**MAINE TURNPIKE AUTHORITY**

**ADDENDUM NO. 2**

**CONTRACT 2021.05**

**YORK TOLL PLAZA DEMOLITION**  
**MILE 7.3**

SHEET NUMBER: BAR-02  
CONTRACT: 2021.05  
17 OF 149

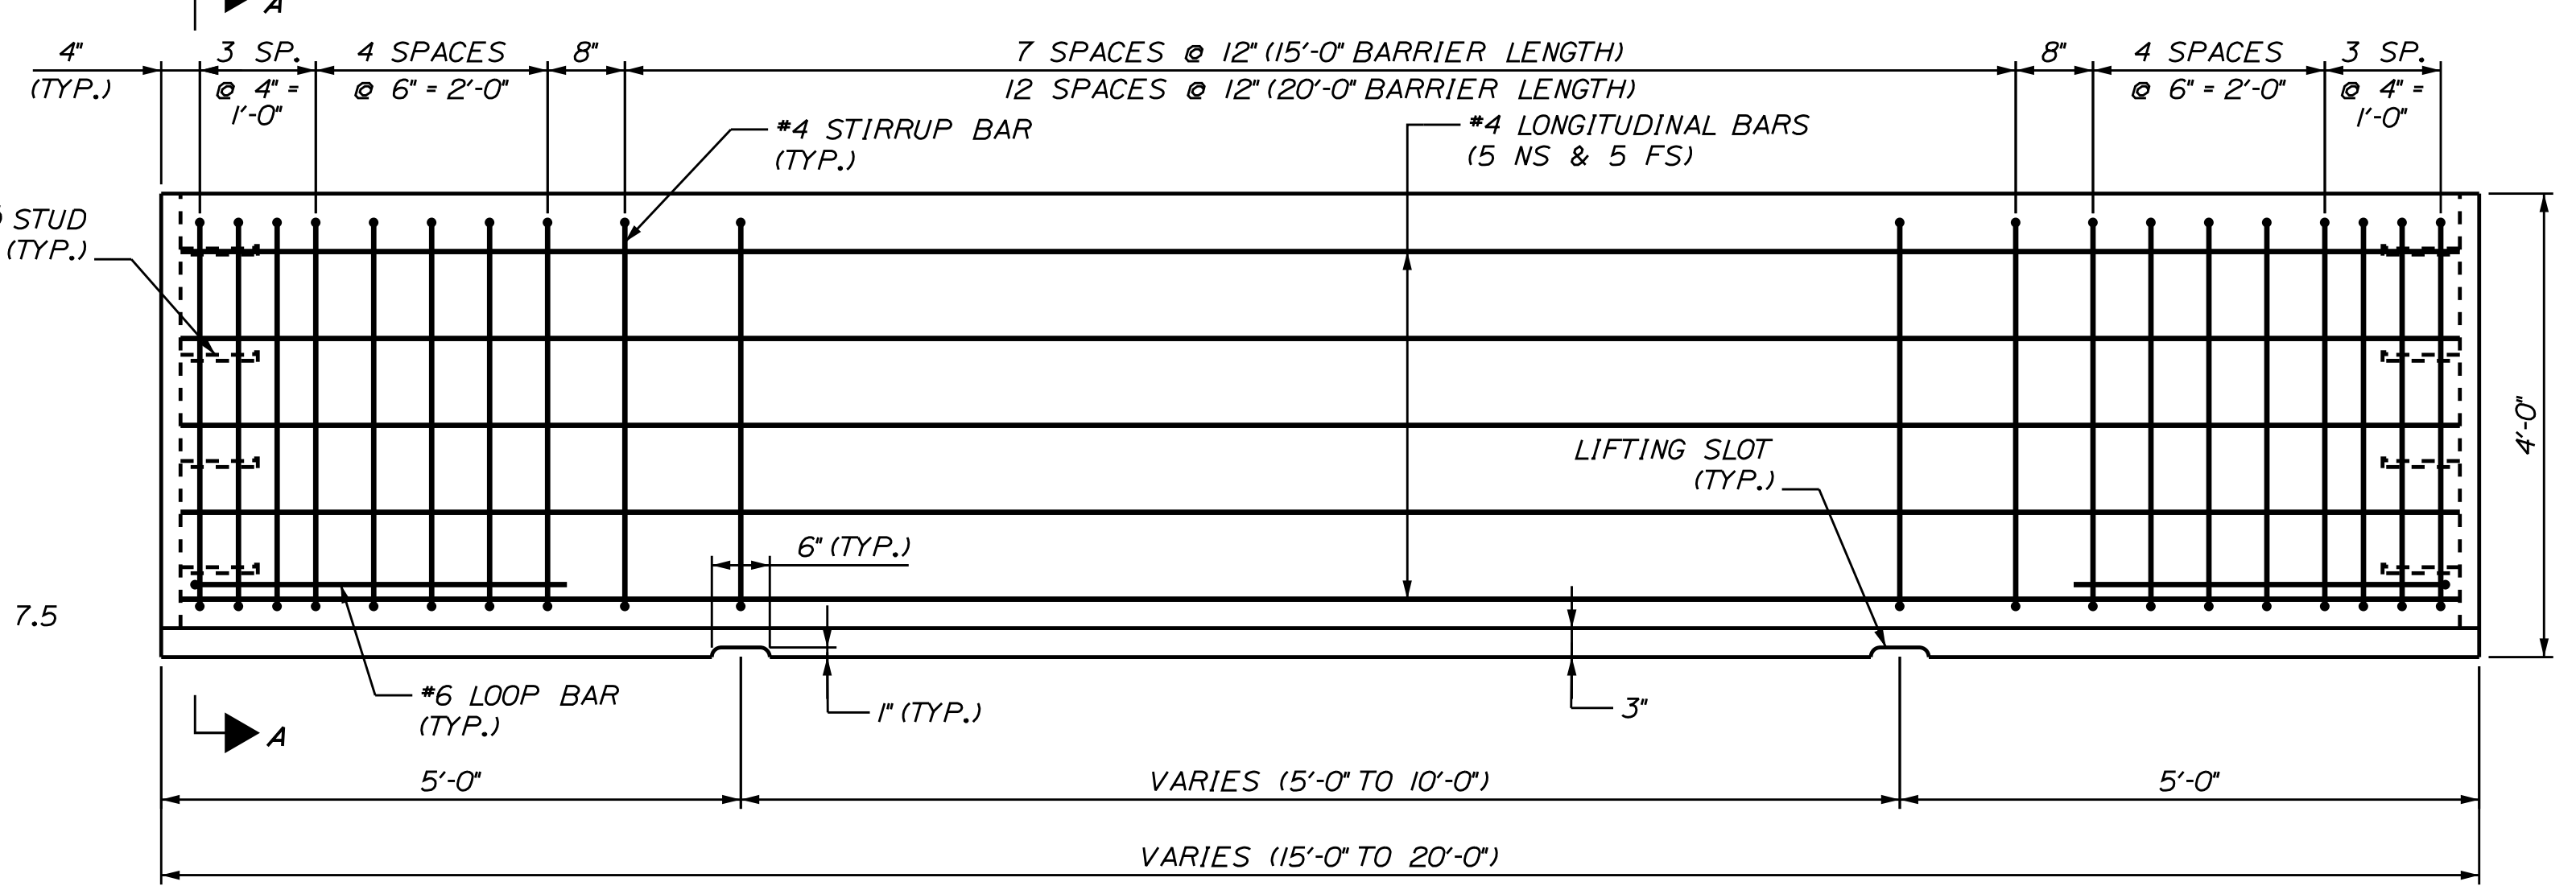
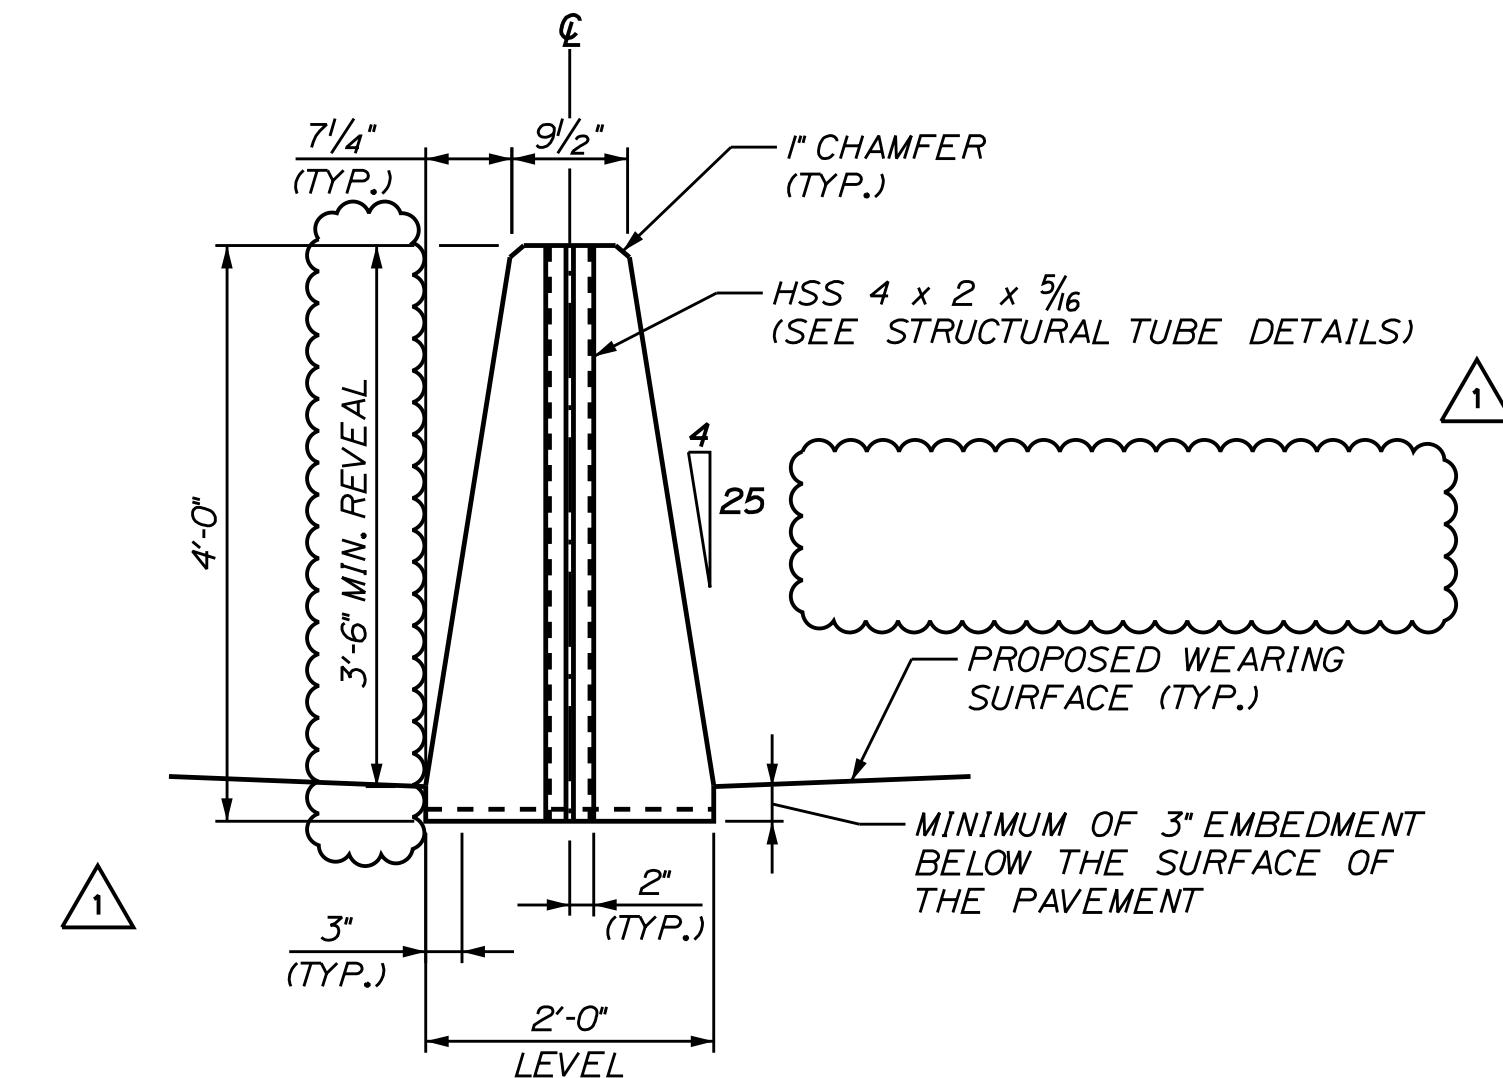
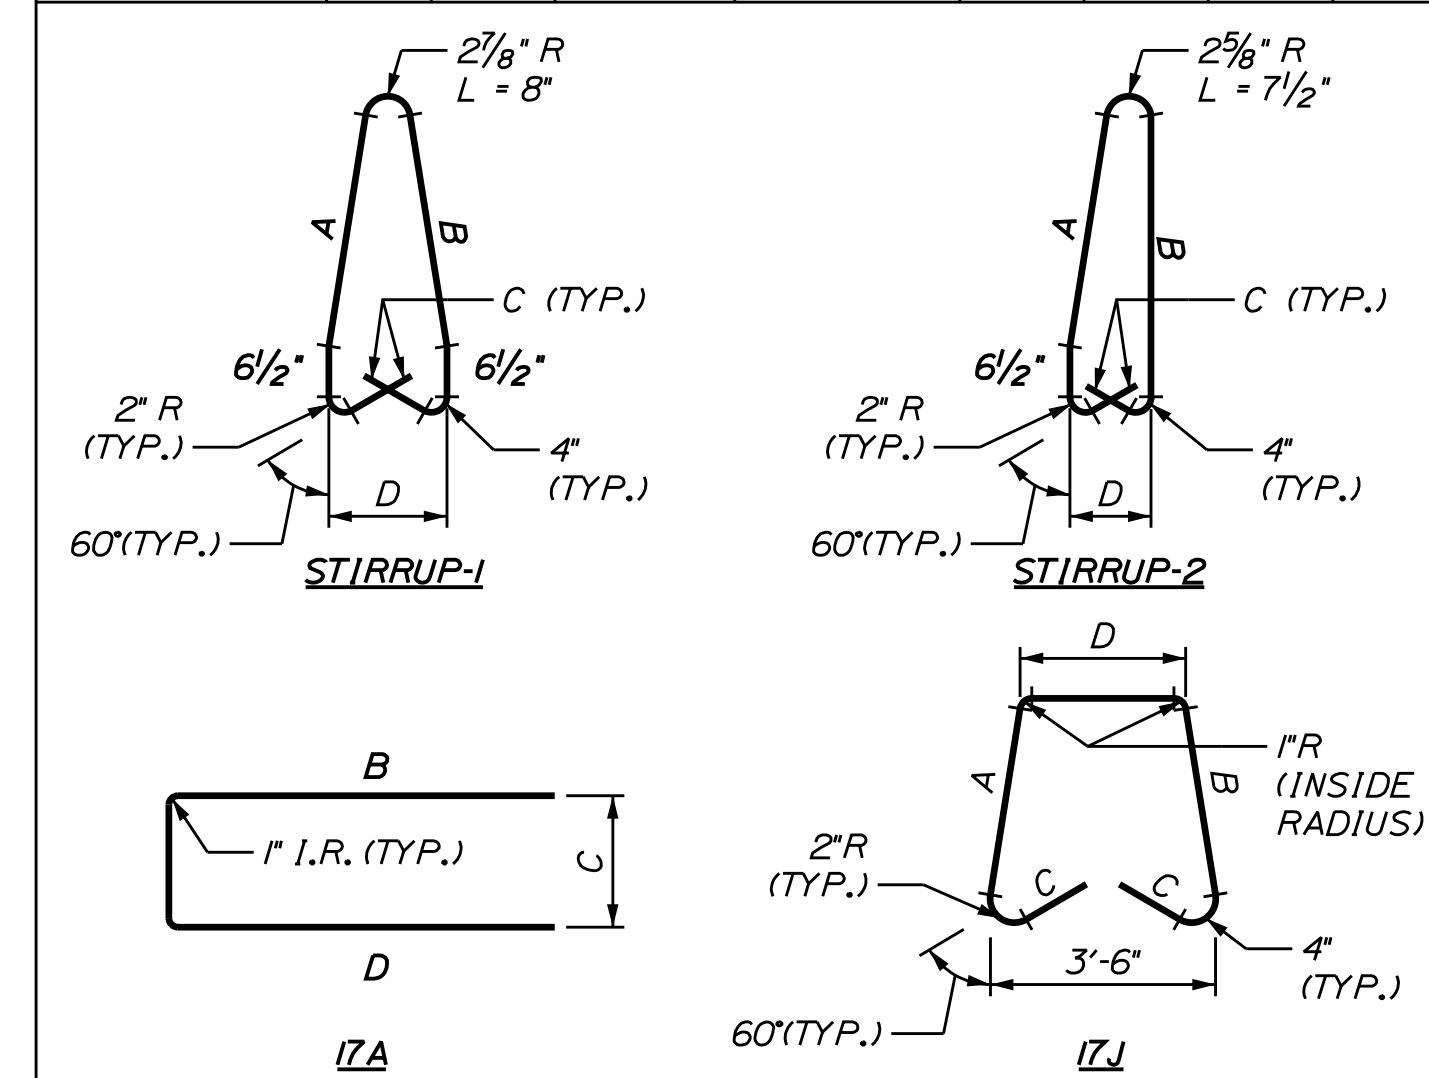
Special Provision 645 – Barrier Reflector added. New item as shown on plan sheet 17 in this addendum. SP-124A, SP-124B, SP-124C added.

SHEET NUMBER: DD-04  
CONTRACT: 2021.05  
24 OF 149

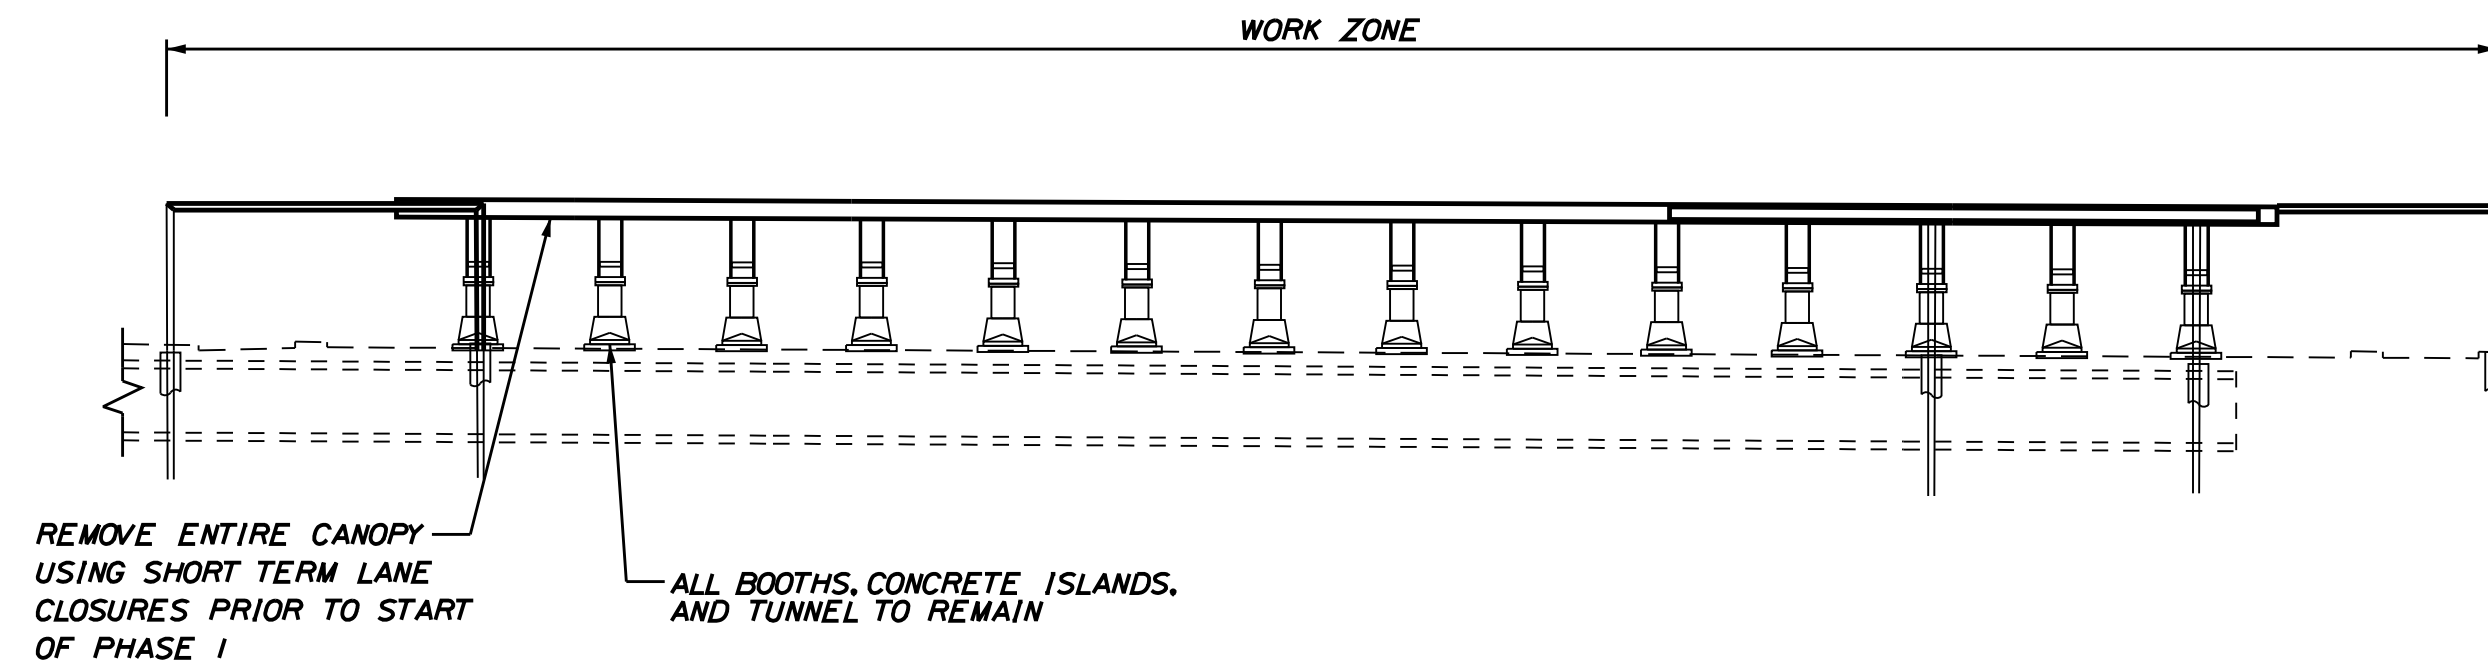
12. The OCS table on dd-04 is different than that in the general plan which is to be used?

**Answer: The callouts on DD-04 and the general plans have been coordinated and plans re-issued.**

SHEET NUMBER: SW-01  
70 OF 149

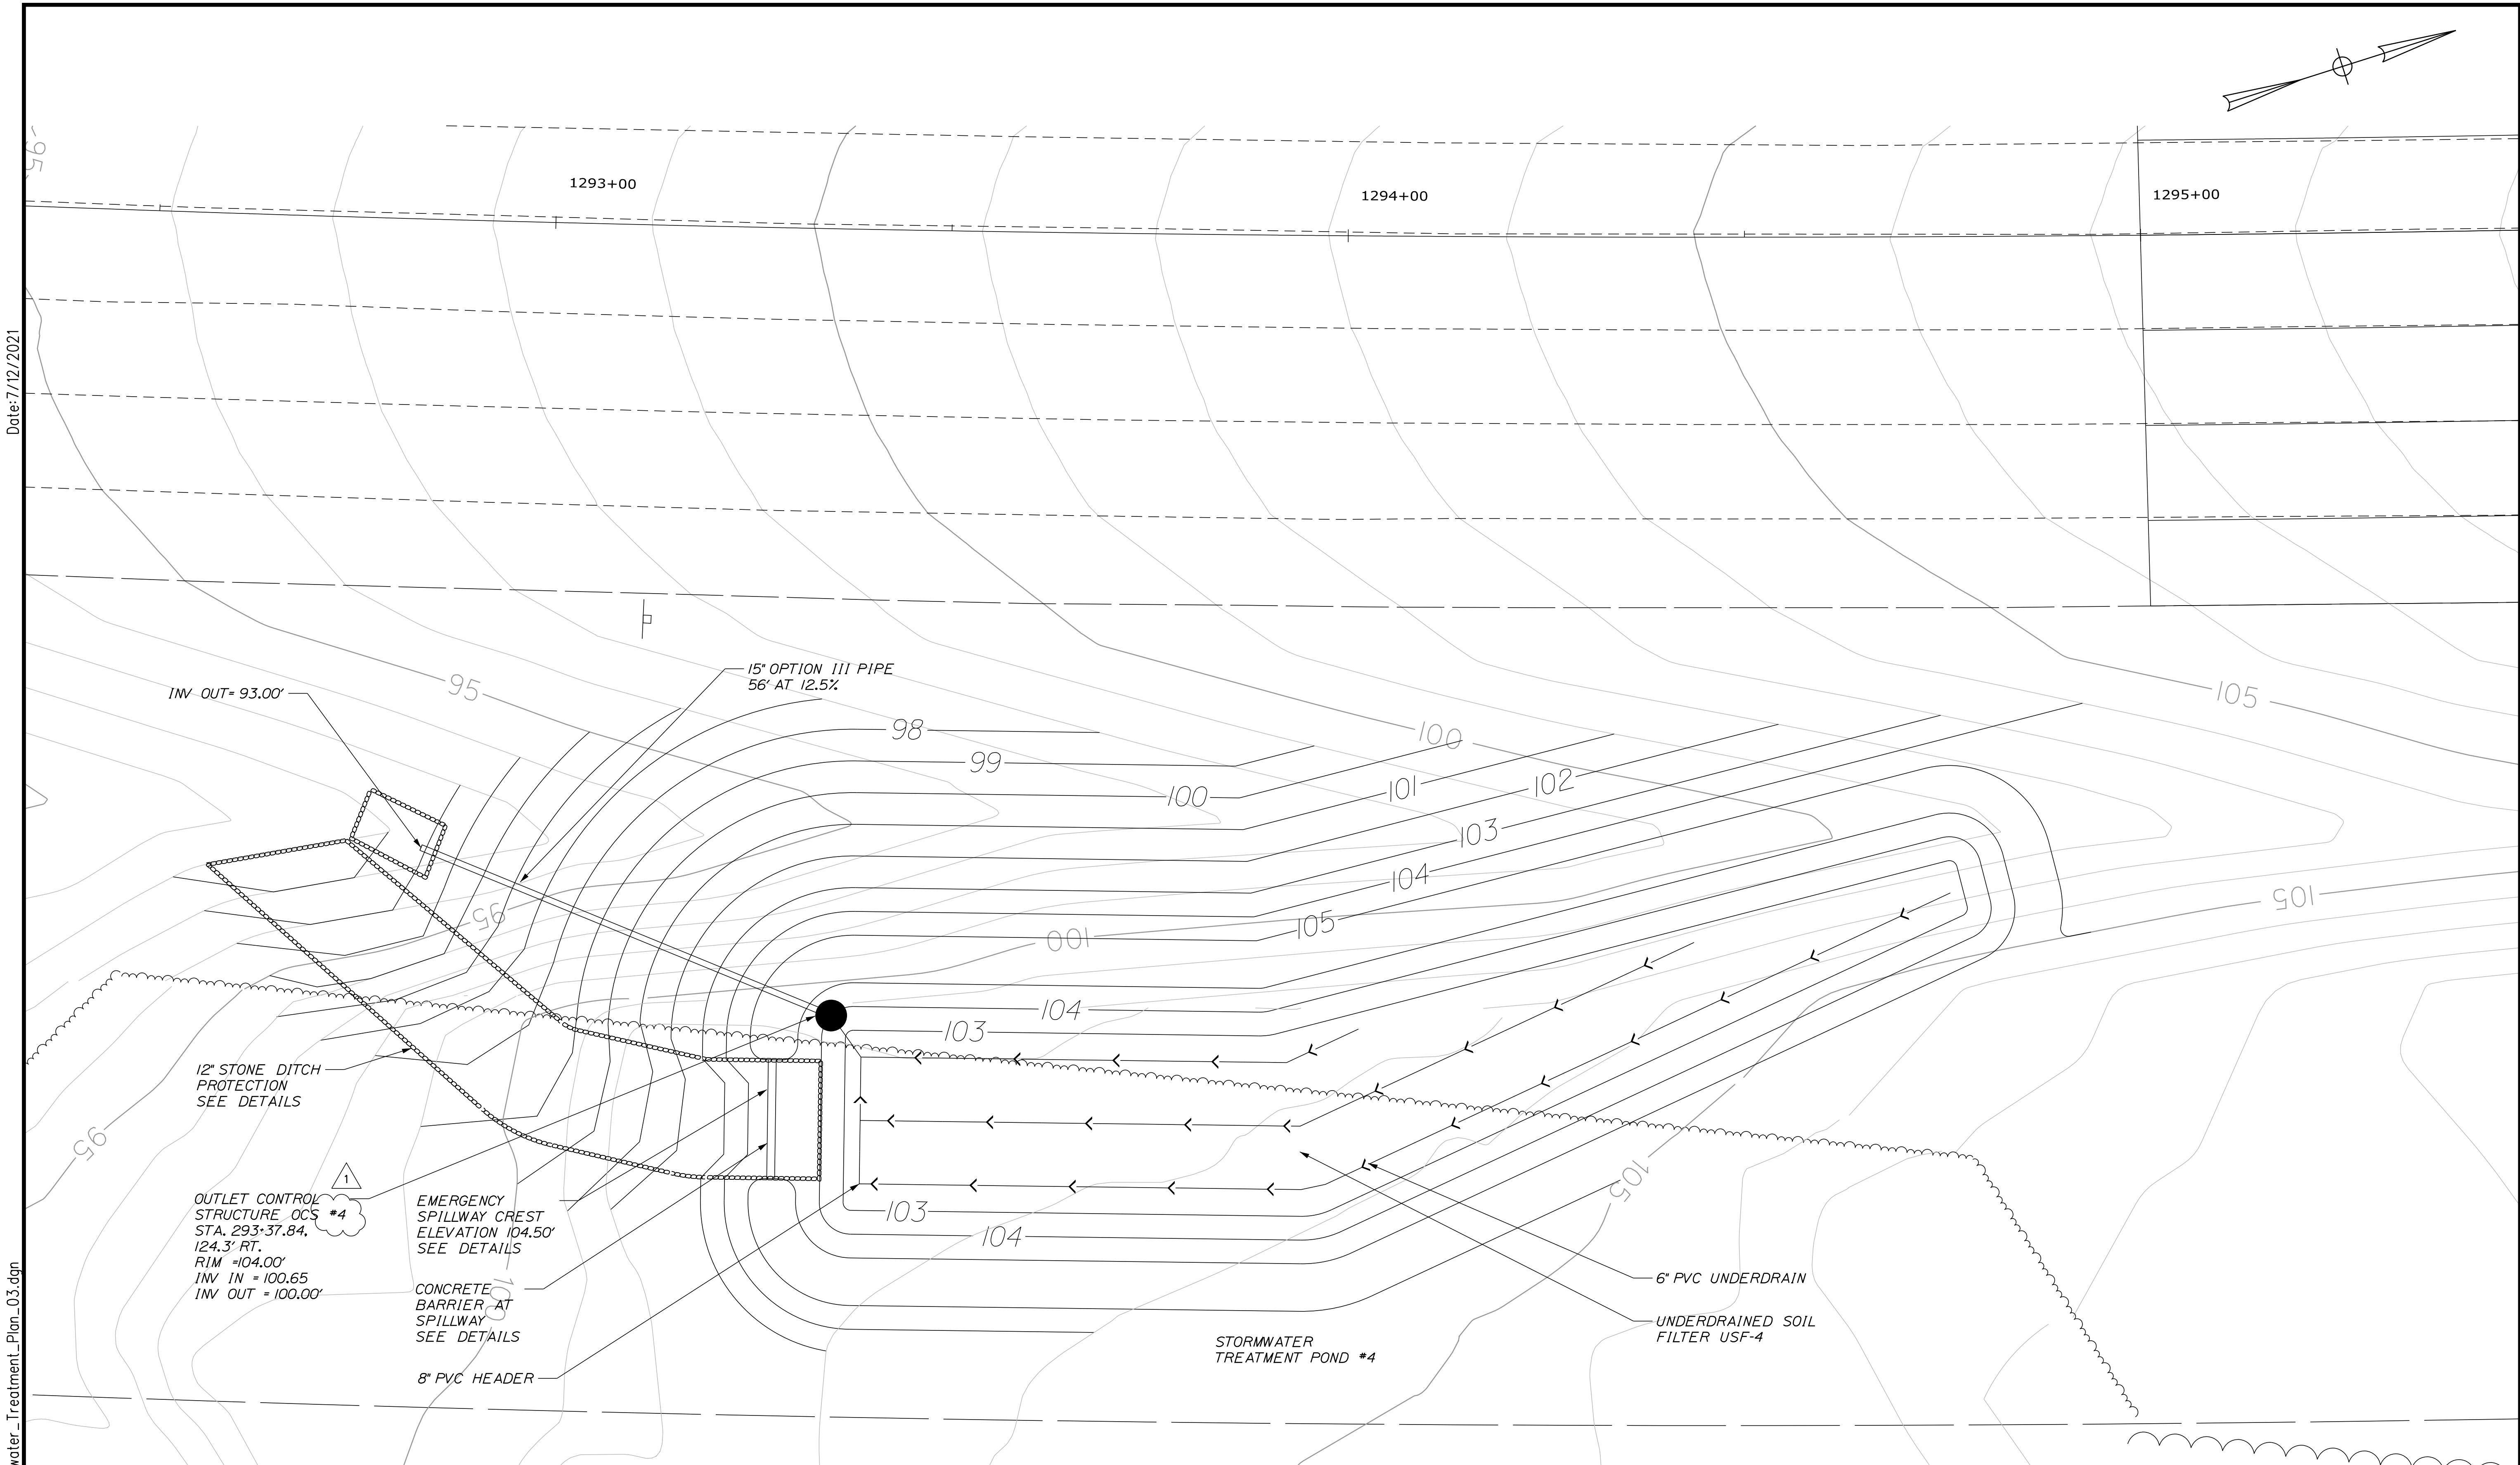
18. The USF 3 & 4 outlet pipes are listed on the plan (sheet 71 & 72) as option III. The drainage schedule (sheet 15) calls them out as RCP. Please advise.

23. Plan sheet 70 of 149 (SW-01) calls out 8" pvc underdrain in the UDSF. We do not find a pay item for 8" underdrain in the schedule of items. Is the 8" underdrain being paid under item 605.105 8 inch underdrain outlet or is it incidental to something.

**Answer: The correct pay item shall be Option III pipe as noted on Sheets 71 and 72, the drainage schedule (sheet 15) has been revised and re-issued.**

**Answer: Each item is paid by respective item per unit cost, otherwise is incidental to 802.01. See question 4 for additional information.**
24. Under what bid item should the concrete barrier and concrete footing at the USF basins be paid under?
